Addendum No. 2
To the Plans and Specifications of

Escambia County Fire-Rescue
Paradise Beach – Station 20
1250 Bauer Road
Pensacola, Florida

Four Pages + Attachment(s)
August 4, 2026

C-201

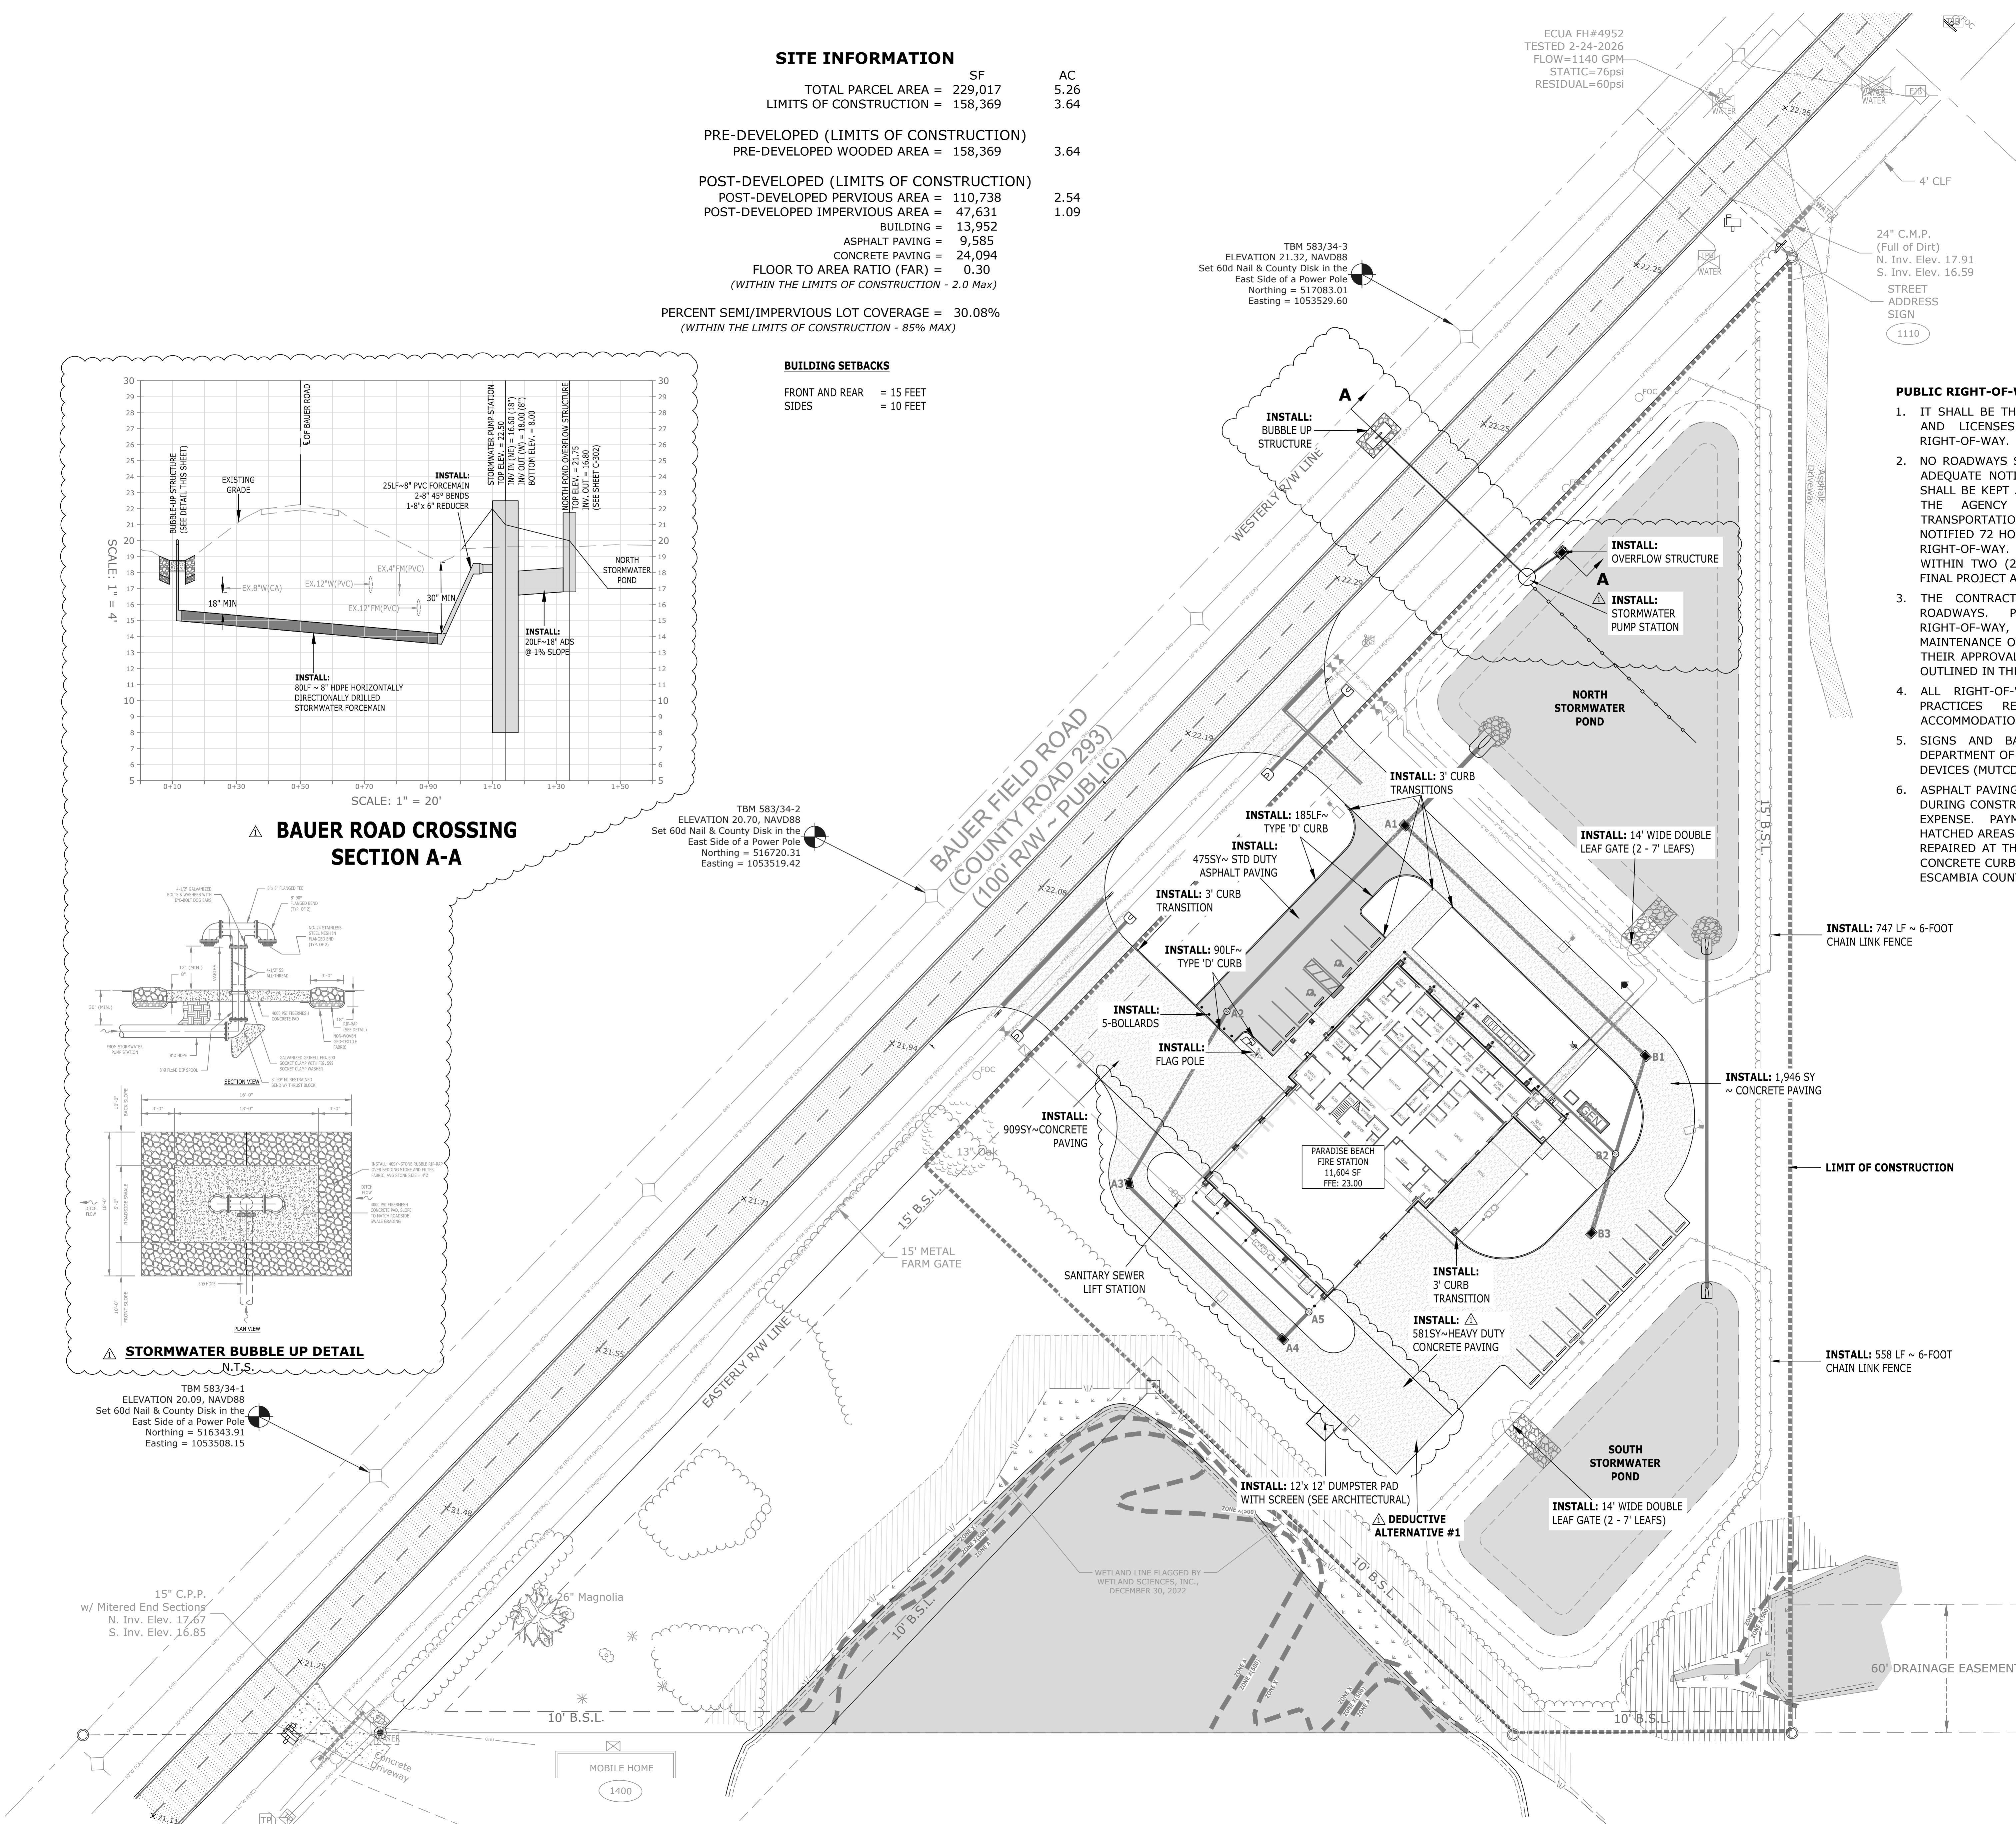
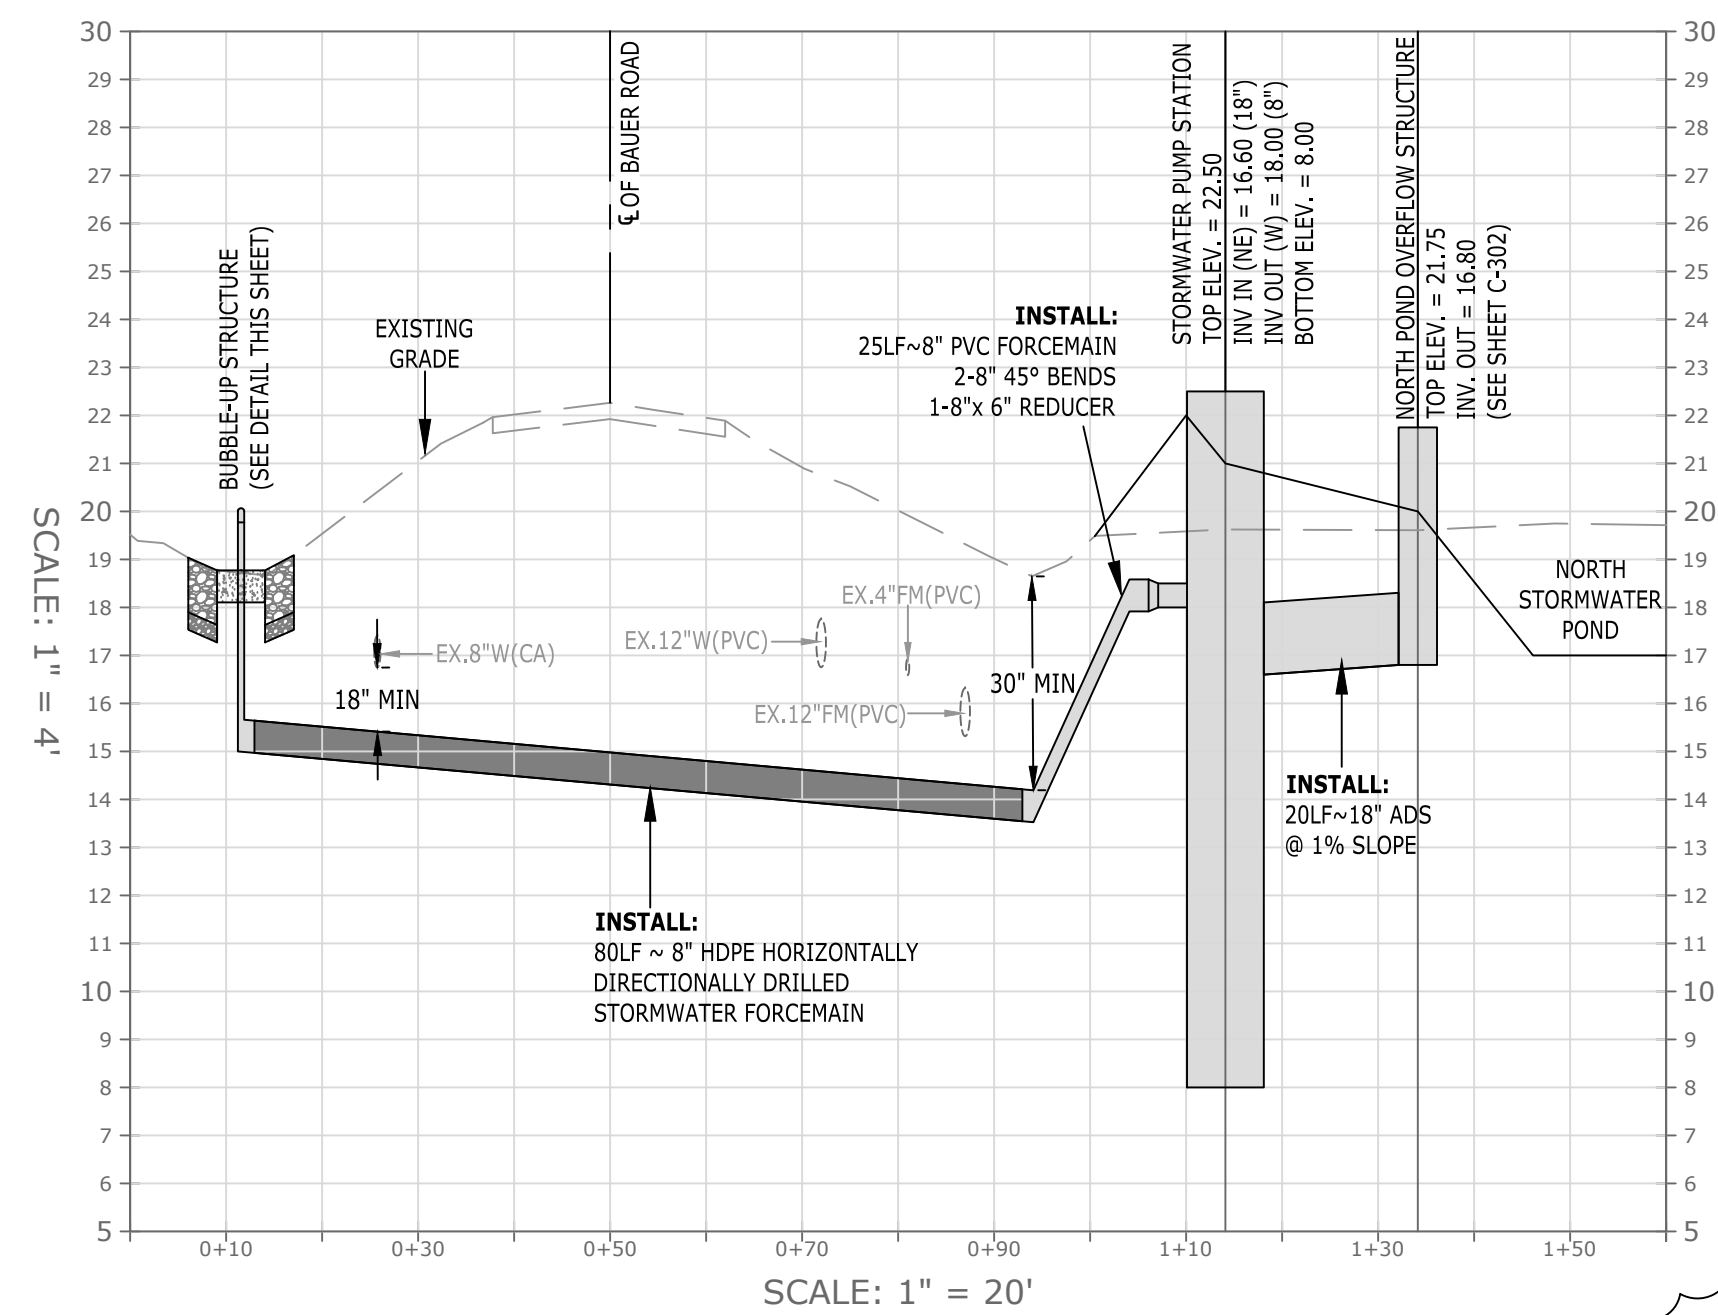
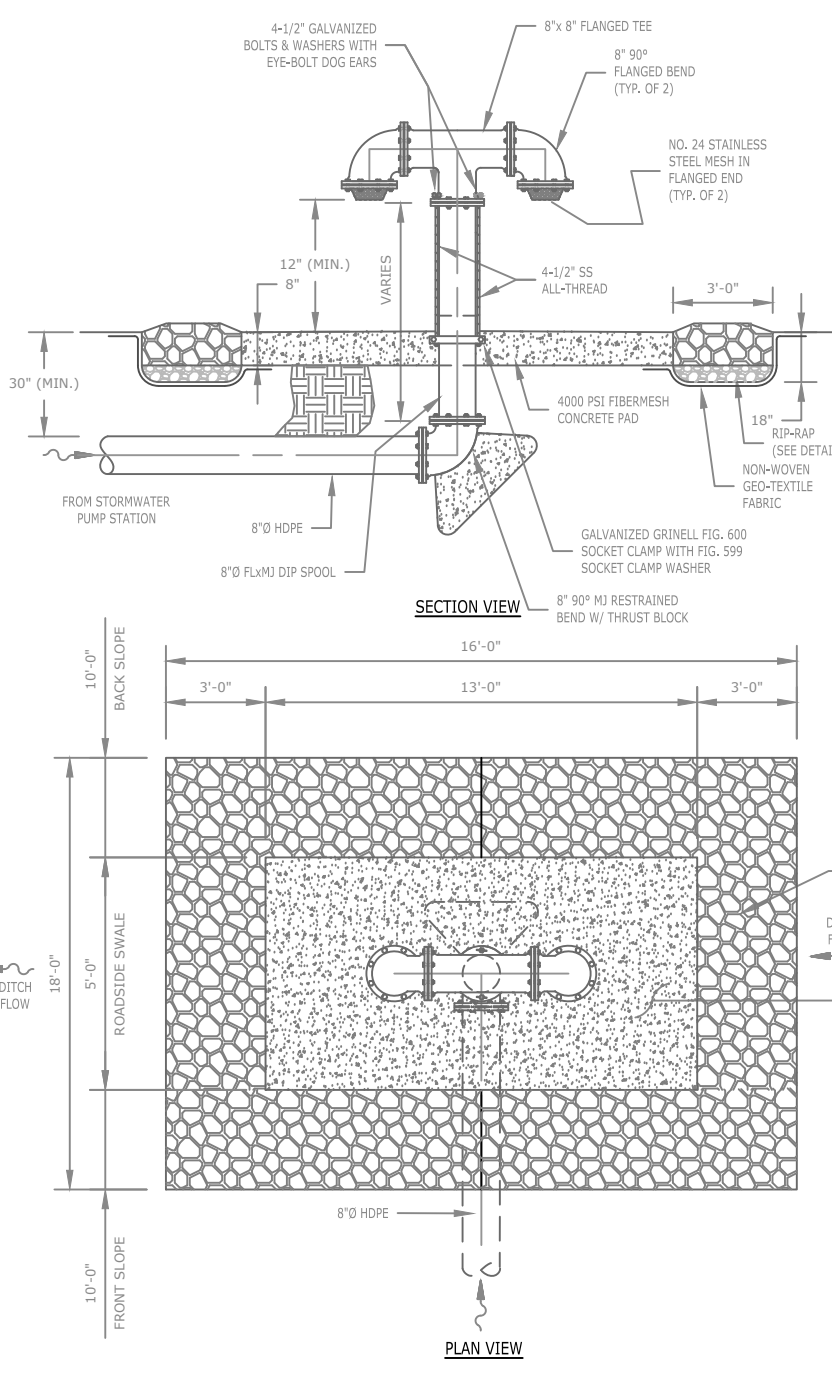
3. Sheet C-201 – This entire sheet has been revised and is attached. Please replace this sheet in the original bid plan set. The specific changes to this sheet include the following:

- a. The pond outfall for the north stormwater pond has been revised from a flooded bubble up to a stormwater pump station.
 - b. The bypass driveway located on the south side of the equipment bay has been labeled as Deductive Alternate No. 1.

- c. The bypass driveway has been changed from asphalt paving to concrete paving.
 - d. A cross-section for the pond outfall has been added to the sheet as well as a bubble-up detail.
